# Access Compliance Report

## Public Rights-of-Way

Intersection ID: 25995	Main Street: WEDDINGTON_RD	Cross Street: PLANTATION_CENTER_DR	Location: SW
ADA ID: 68CCE6F13AEE	Ramp Type: Para	Initial Pass/Fail: Fail	Overall Compliance: No
Codes/Mitigation Info/Possible Solution		Field Measurements/Component Compliance	
Severity Score: 26.25

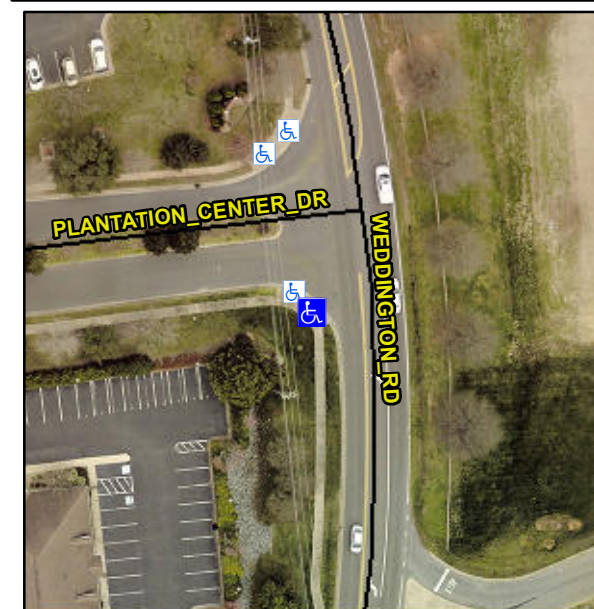
**Remove & Replace Entire Ramp.**

**R304.5.3, R304.3.2**

Compliance	Description	Data	Compliance	Description	Data
N/A	Ramp Length LT (in)	59.0	N/A	Ramp Length RT (in)	57.0
Yes	Ramp Width LT (in)	108.0	Yes	Ramp Width RT (in)	108.0
Yes	Ramp Slope LT (%)	5.4	No	Ramp Slope RT (%)	12.4
No	Ramp XSlope LT (%)	2.4	Yes	Ramp XSlope RT (%)	1.4
N/A	Landing Length (in)	N/A	N/A	DWS Provided?	N/A
N/A	Landing Width (in)	N/A	N/A	DWS Contrast?	N/A
N/A	Landing Slope (%)	N/A	N/A	DWS Length (in)	N/A
N/A	Landing X Slope (%)	N/A	N/A	DWS Full Width?	N/A
N/A	Landing Curb? (Y/N)	N/A	N/A	DWS Offset (in)	N/A
N/A	Shared Landing?	N/A			
N/A	Gutter Ponding?	N/A	N/A	Gutter Slope (%)	N/A
N/A	Gutter Lip Ht (in)	N/A	N/A	Gutter X Slope (%)	N/A
N/A	Painted X Walk1?	No	N/A	Painted X Walk2?	N/A
	X Walk 1 Direction	To E		X Walk 2 Direction	N/A
N/A	X Walk 1 Width (in)	N/A	N/A	X Walk 2 Width (in)	N/A
	X Walk 1 Slope (%)	3.0		X Walk 2 Slope (%)	N/A
	X Walk 1 X Slope (%)	3.6		X Walk 2 X Slope (%)	N/A
N/A	Ramp inside XWalk1?	N/A	N/A	Ramp inside XWalk2?	N/A
